This amendment revises the Technical Specifications to support operation of Crystal River Unit No. 3 during the remainder of Cycle 1 with 4 fuel assemblies acquired from Oconee Unit 1 and without Burnable Poison Rod Assemblies and most Orifice Rod Assemblies. In addition, Quadrant Power Tilt limits are changed to compensate for increased detector uncertainties and administrative use of revised reactor coolant pressure-temperature limits has been reviewed.

CRYSTAL RIVER UNIT 3 NUCLEAR GENERATING PLANT  
AMENDMENT TO FACILITY OPERATING LICENSE

Amendment No. 16  
License No. DPR-72

ATTACHMENT TO LICENSE AMENDMENT NO. 16

Figure 2.1-2

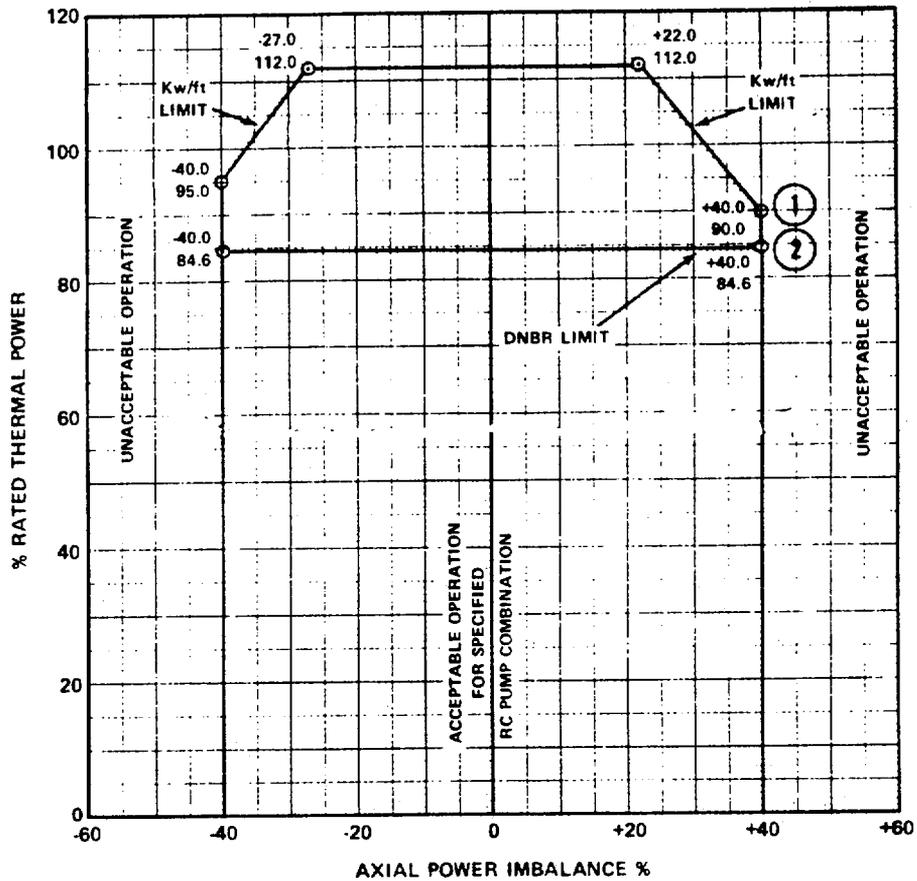
The curves of Figure 2.1-2 are based on the more restrictive of two thermal limits and account for the effects of potential fuel densification and potential fuel rod bow:

The specified flow rates for curves 1 and 2 of Figure 2.1-2 correspond to the expected minimum flow rates with four pumps, three pumps, and one pump in each loop, respectively.

Regulating Rod Group Insertion Limits for 4 Pump Operation From 268.8 EFPD to 400 ± 10 EFPD

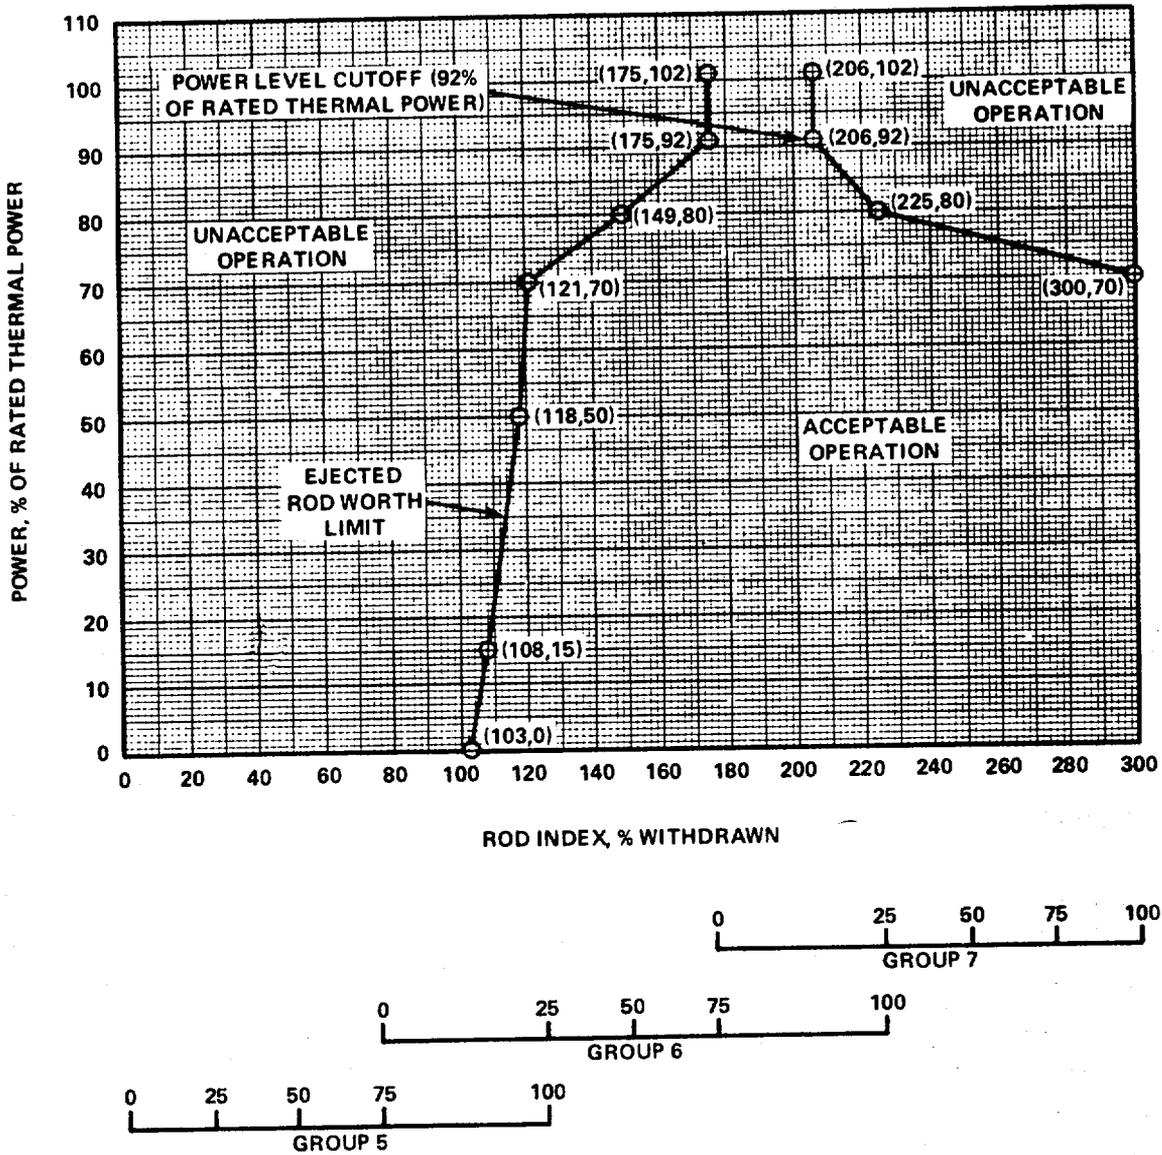
The power-imbalance envelope defined in Figure 3.2-1 and the insertion limit curves, Figures 3.1-1, 3.1-2, 3.1-3, 3.1-4 and 3.1-9, are based on LOCA analyses which have defined the maximum linear heat rate such that the maximum clad temperature will not exceed the Final Acceptance Criteria of 2200°F following a LOCA. Operation outside of the power-imbalance envelope alone does not constitute a situation that would cause the Final Acceptance Criteria to be exceeded should a LOCA occur. The power-imbalance envelope represents the boundary of operation limited by the Final Acceptance Criteria only if the control rods are at the insertion limits, as defined by Figures 3.1-1, 3.1-2, 3.1-3, 3.1-4, and 3.1-9, and if the steady state limit QUADRANT POWER TILT exists. Additional conservatism is introduced by application of:

Figure 3.1-9  
 Axial Power Shaping Rod Group Insertion Limits  
 After 268.8 EFPD

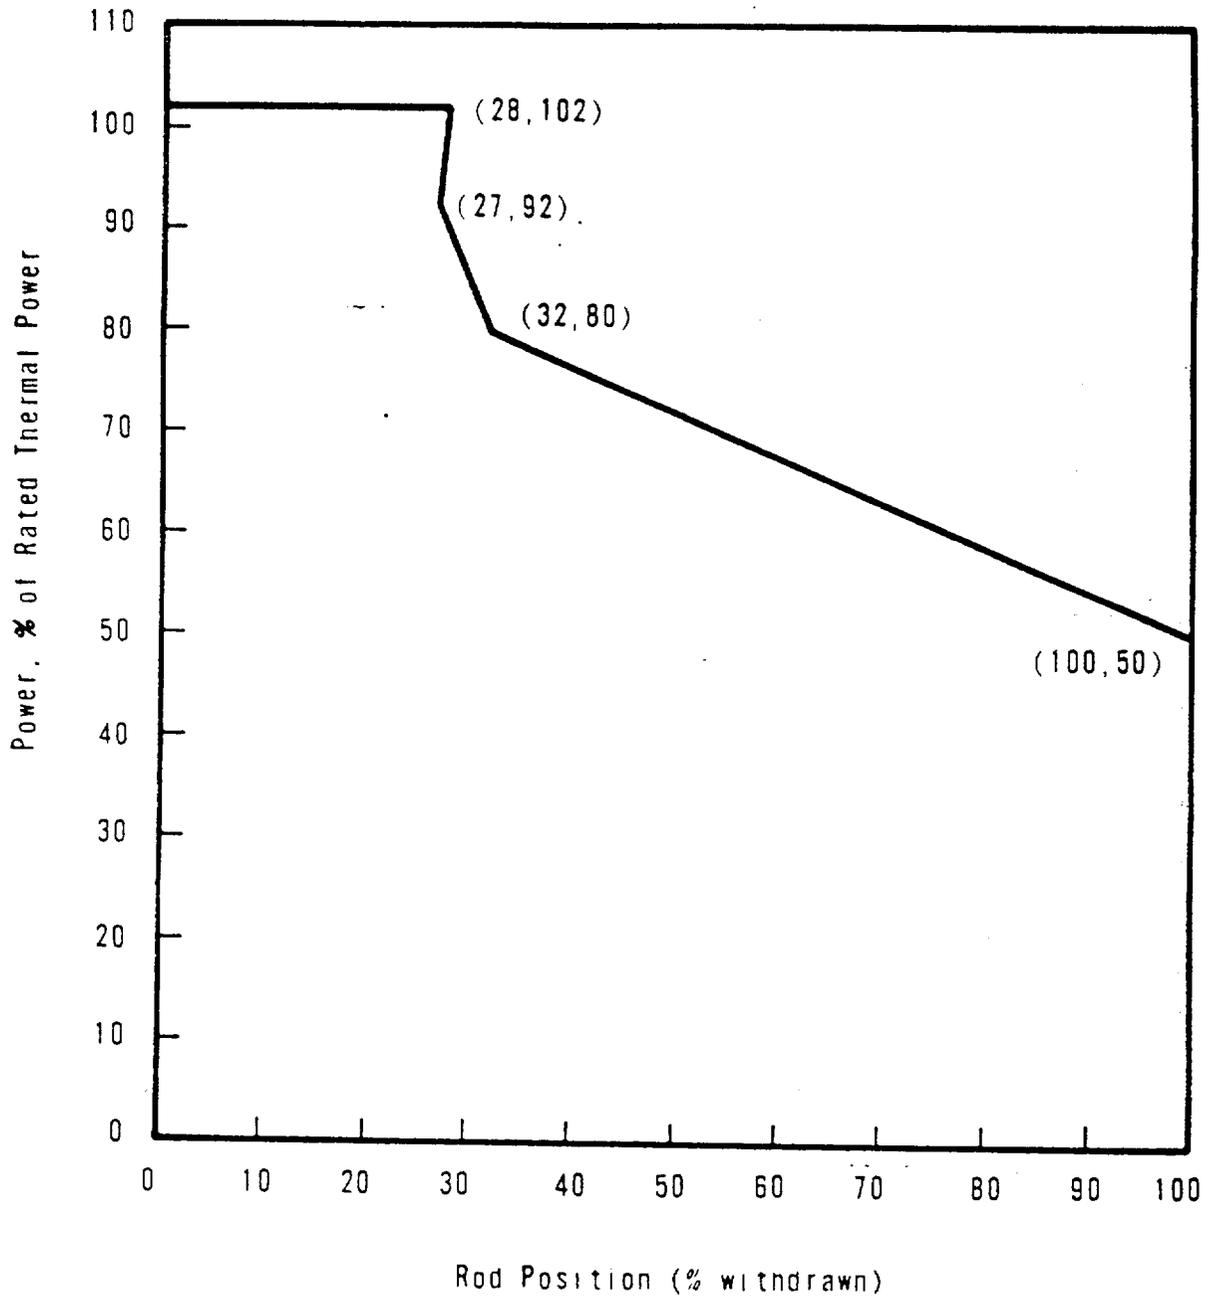
3.1.3.9 The axial power shaping rod group shall be limited in physical insertion as shown on Figure 3.1-9.
